SC(2)(WK) Paper No.: LWK5

West Kowloon Competition, URGENT

West Kowloon Competition, Urgent: Some technical concern

Write up on parcellation and phasing, West Kowloon Competition

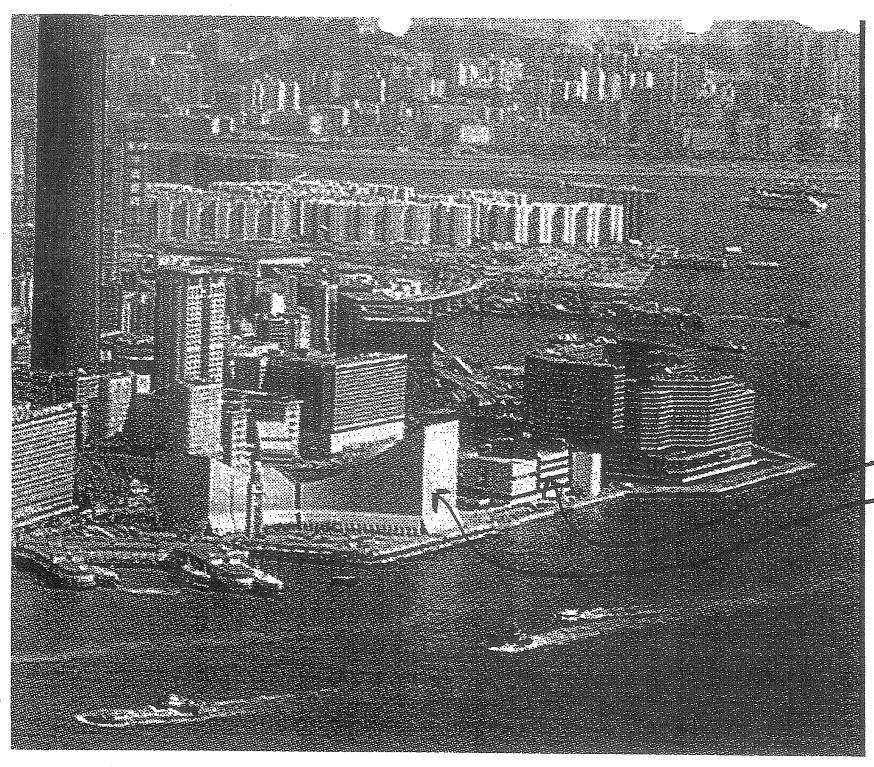
- 1. Connection to MTR and KCRC station through travellators should be indicated
- 2. The retail and Cultural circulation pattern should be crossed and interchanged at some points
- . The MRT line should be extended to land on Kowloon Park and terminated at the TST station, Luke will send you the plan
- 4. Both the recreational loop and retail strip should be shown extended towards the gateways, china HK City and the Habour City. Luke will show you the plan.

1.Linkage to Kowloon Park should be shown
